XR500 and XR100 Series Feature Update
November 2006

Version 116 Software Update

Effective November 2006, all XR500 and XR100 Series panels are being manufactured with Version 116 (11/13/06) software. This version is an update from the Version 115 (9/26/06) software previously shipped and contains new features

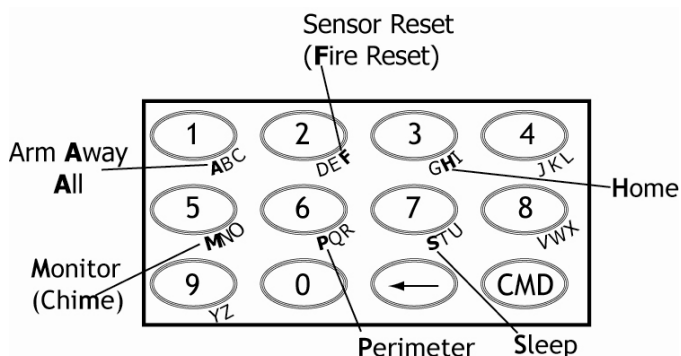
The Perimeter, All, Home, Sleep and Away area assignment selections have been added for the 1100 Series Wireless Key Fobs.

In an Area system, this specifies the areas to be armed/disarmed by the Key Fob button being programmed. To select an area between 1 and 32, enter the area number using the keypad digit keys. Default is no areas enabled.

In order to arm or disarm selected areas, the Profile assigned to the User Number needs to have the same area numbers selected. Any area may be selected at Arm/Disarm Areas but only matching area numbers are armed or disarmed when the specific button is pressed. For example, in Areas selection, areas 1, 3, and 7 are selected. In the User Profile Arm and Disarm Areas, areas 1, 2, 4, and 7 are selected. When the user presses the button to Arm or Disarm area(s), only matching areas 1 and 7 Arm/Disarm.

In an All/Perimeter or Home/Sleep/Away system, this specifies the area to be armed by the Key Fob button being programmed. For All/Perimeter systems, choose PERIM or ALL, for Home/Sleep/Away or Home/Away systems, choose HOME, SLEEP, or AWAY.
